R26 RELAY REMOVAL AND WATER PUMP GROUND MODIFICATION

Prevost vehicles

On the vehicles affected by this bulletin, remove relay R26, isolate and/or reconnect wires according to the wiring diagram D061670 P18.2 revision 8. Also move water pump ground connection to the electronic ground pin A54 J2.14 and rename circuit gnd-0EVAP2-14.

Figure 1

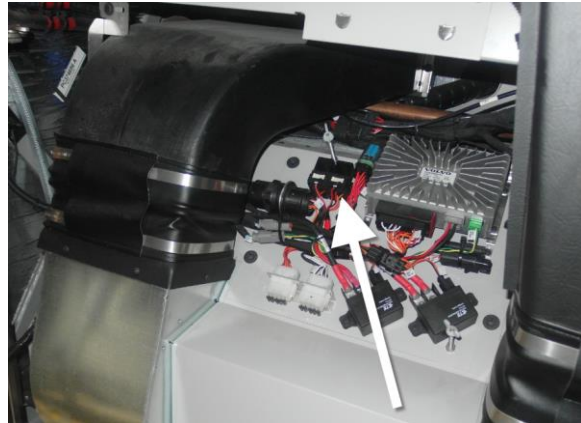
1. Locate Relay R26 into the evaporator compartment.

Figure 2

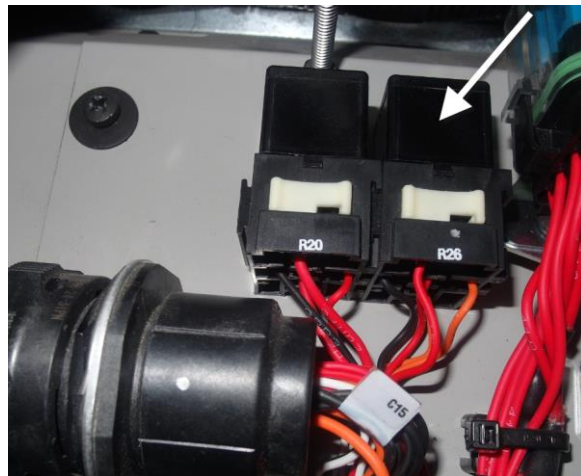
2. Remove relay R26 from its base. You do not need a special tool for this operation. You just pull it out upward.

Figure 3

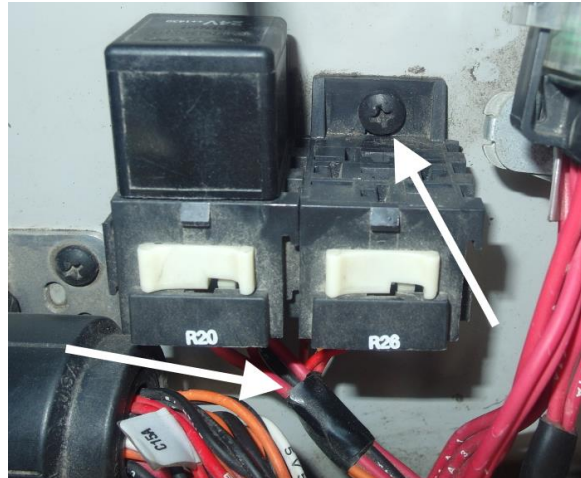
- Remove black tape around the wiring. Be careful to avoid any wiring damage with the knife.
- Remove the screw from the R26 relay base.

Figure 4

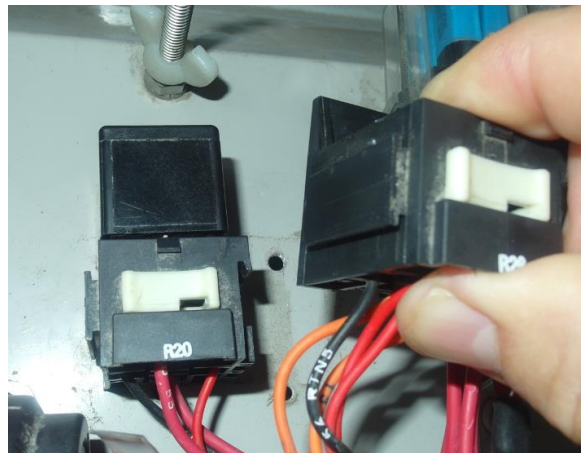
- Slide out the R26 relay base.

Figure 5

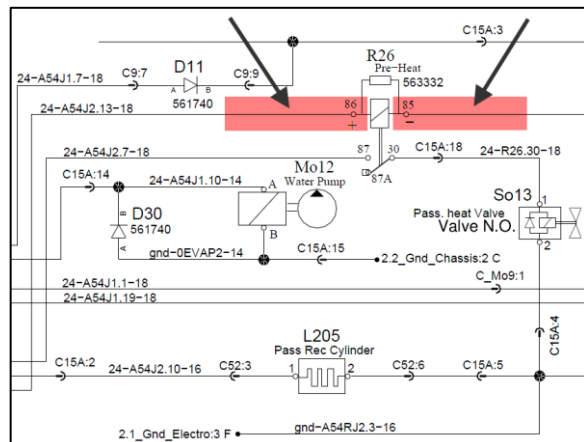
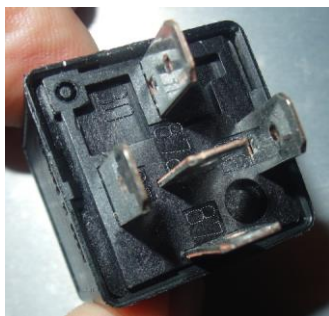
- Cut circuit R26.85 and circuit R26.86 close to the R26 relay base to keep a length of wire for the next step. Connection ID is written on the relay.

Figure 6

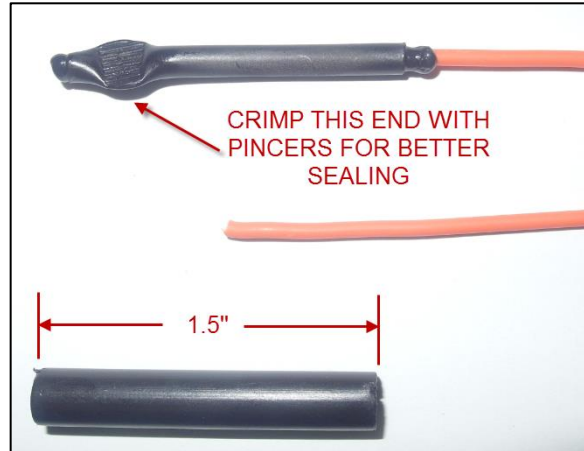
- Isolate the two cut wires with 1.5" length of shrink tubing part # 560784. Insert wire $\frac{3}{4}$ " into the shrink tubing before eating it.

Figure 7

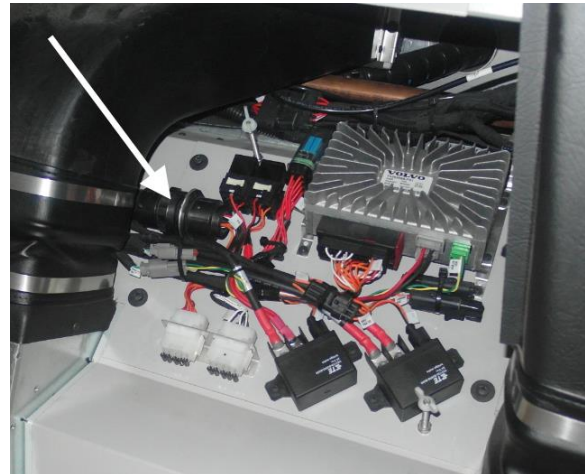
- Locate connector C15A into the evaporator compartment.

Figure 8

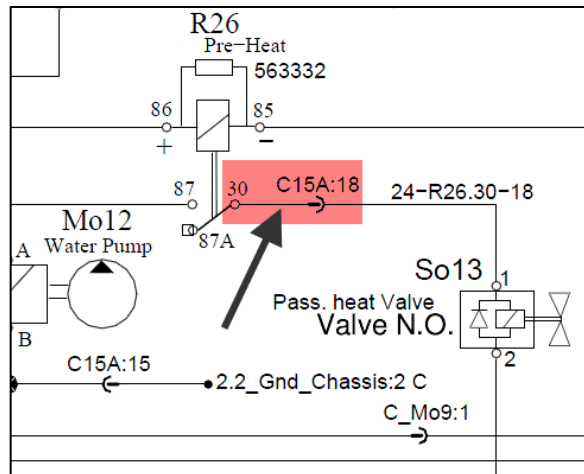
- Cut circuit R26.30 from R26 relay base and disconnect it from connector C15A:18. Use blue extractor # 682321 for the extraction of the terminal in connector C15A.

Figure 9

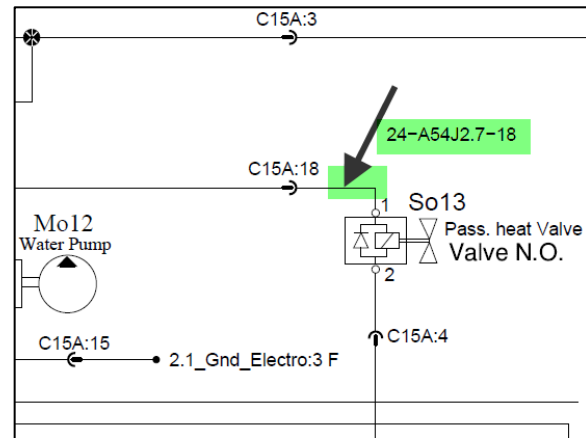
- Use a P-Touch printer to make a label with the new name of this wire 24-AE54J2.7-18. Install this label on the wire between C15A18 and port 1 of So13 valve.

Figure 10

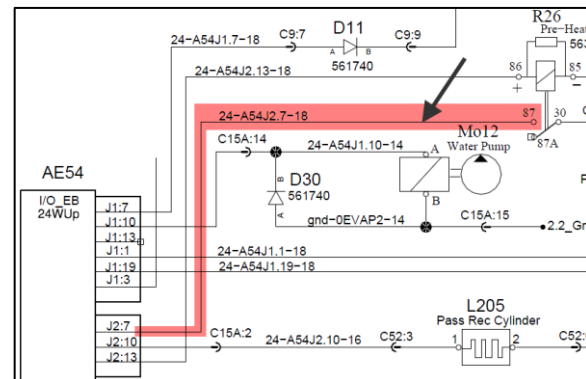
- Cut wire 24-A54J2.7 from R26-87 and disconnect this wire from AE54J2.7 module connection.

Figure 13

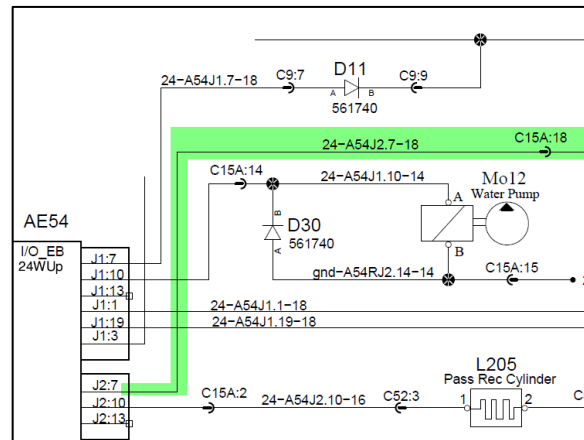
16. Connect orange wire from the kit to AE54J2.7 and C15A:18.
17. Use a P-Touch printer to make a label with the name of this circuit 24-AE54J2.7-18. Install this label on this orange wire.

Figure 14

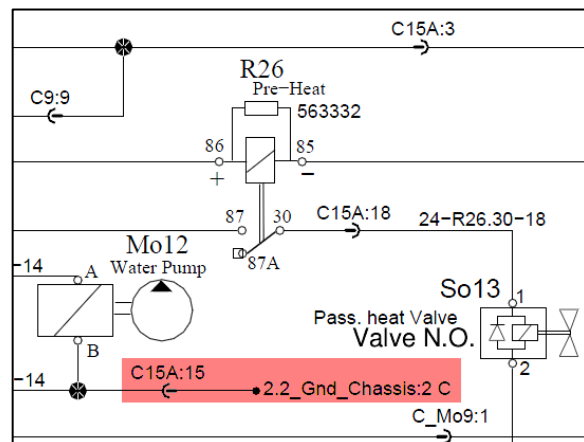
18. Disconnect wire 2.2_Gnd_Chassis:2 C from connector C15A:15.
19. Cut the terminal.
20. Isolate the wire as shown in step 7.

Figure 15

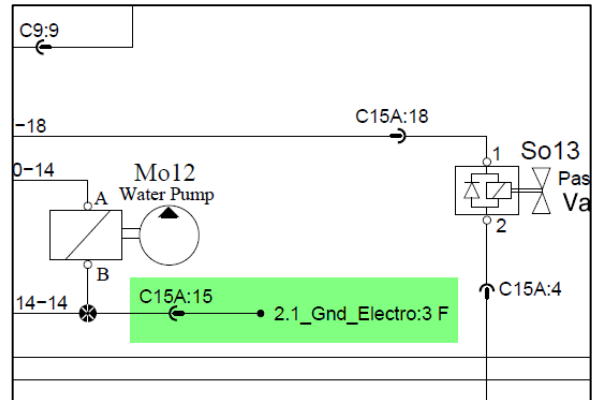
21. Connect the black wire form the kit to connector C15A:15 and to the Module AE54J2-14.
22. Use a P-Touch printer to make a label with the new name 2.1_Gnd_Electro:3F. Install this label on this black wire.

Figure 16

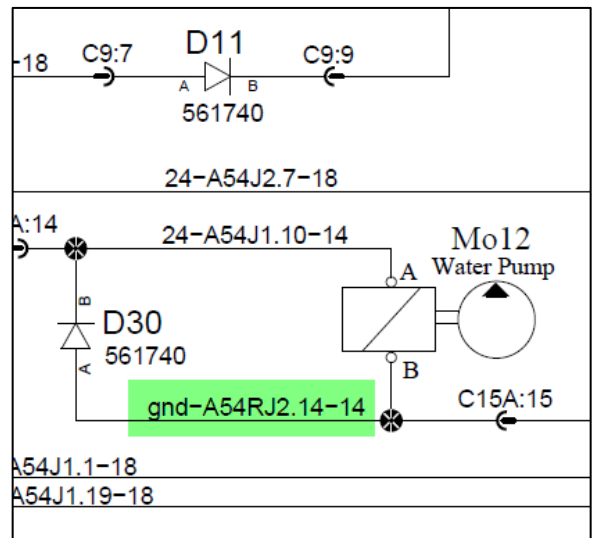
23. Rename wire gnd-OEVAP2-14. The new name is gnd-A54RJ2.14-14. Use a P-Touch printer to make a label and install this label on this.
24. If necessary, use nylon ties to fixe wires together.
25. Bulletin is complete.
